Access Compliance Report

Public Rights-of-Way

(Curb Ramps)

Intersection ID: 16569	Main Street: FOREST_PARK_DR	Cross Street: PRINCETON_AV	Location: NE
ADA ID: 89335291316F	Ramp Type: ParaDiag	Initial Pass/Fail: Pass	Overall Compliance: No
Codes/Mitigation Info/Possible Solution			Severity Score: 15
			Field Measurements/Component Compliance

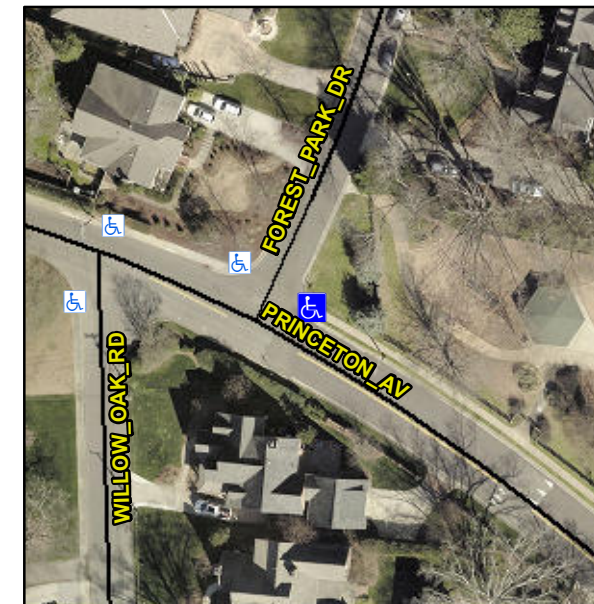
RAMP LIP 1.0, LT RP < 5%

R304.2.2-Perp, R304.3.2-Para, R304.5.3, R305, R304.5.4

Compliance	Description	Data	Compliance	Description	Data
N/A	Ramp Length LT (in)	48.0	N/A	Ramp Length RT (in)	22.0
Yes	Ramp Width LT (in)	48.0	Yes	Ramp Width RT (in)	54.0
Yes	Ramp Slope LT (%)	1.2	Yes	Ramp Slope RT (%)	6.7
Yes	Ramp XSlope LT (%)	0.3	Yes	Ramp XSlope RT (%)	0.6
Yes	Landing Length (in)	50.0	No	DWS Provided?	No
Yes	Landing Width (in)	52.0	N/A	DWS Contrast?	No
No	Landing Slope (%)	3.6	N/A	DWS Length (in)	N/A
No	Landing X Slope (%)	3.3	N/A	DWS Full Width?	No
N/A	Landing Curb? (Y/N)	No	N/A	DWS Offset (in)	N/A
N/A	Shared Landing?	No			
Yes	Gutter Ponding?	No	No	Gutter Slope (%)	10.5
Yes	Gutter Lip Ht (in)	0.0	Yes	Gutter X Slope (%)	0.2
N/A	Painted X Walk1?	No	N/A	Painted X Walk2?	No
	X Walk 1 Direction	To W		X Walk 2 Direction	To S
N/A	X Walk 1 Width (in)	N/A	N/A	X Walk 2 Width (in)	N/A
	X Walk 1 Slope (%)	5.0		X Walk 2 Slope (%)	7.3
	X Walk 1 X Slope (%)	7.8		X Walk 2 X Slope (%)	5.2
N/A	Ramp inside XWalk1?	N/A	N/A	Ramp inside XWalk2?	N/A

Remove & Replace Curb Ramp With Two New Directional Ramps or Equivalent. Remove & Replace Gutter.
